# **PRODUCT CHANGE NOTICE**

## **Package Orientation Change for Tray Packing of the Listed Intersil Products**

**Refer to:  
PCN12066**

**Date: August 8, 2012**

### Products ISL8200MIRZ

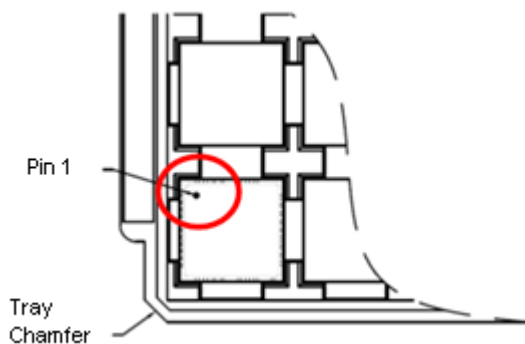
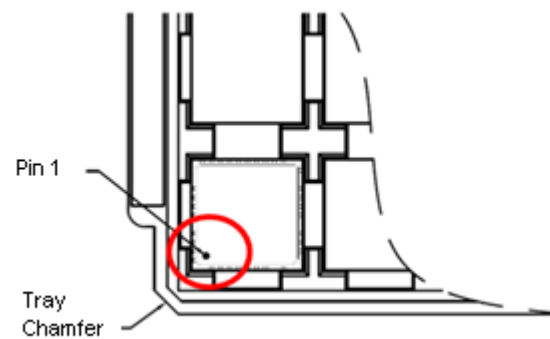
This notice is to inform you that Intersil is changing the package orientation for tray packing of the listed QFN (Quad Flat No-Lead) plastic packaged products. The change in package orientation aligns pin 1 of the device with the tray chamfer/notch and is in accordance with established industry standards for packing of IC products. Diagrams depicting the changes in package orientation are included on the next page for reference. There will be no change in the trays (i.e. dimensions, materials, appearance, etc.) used for product shipment.
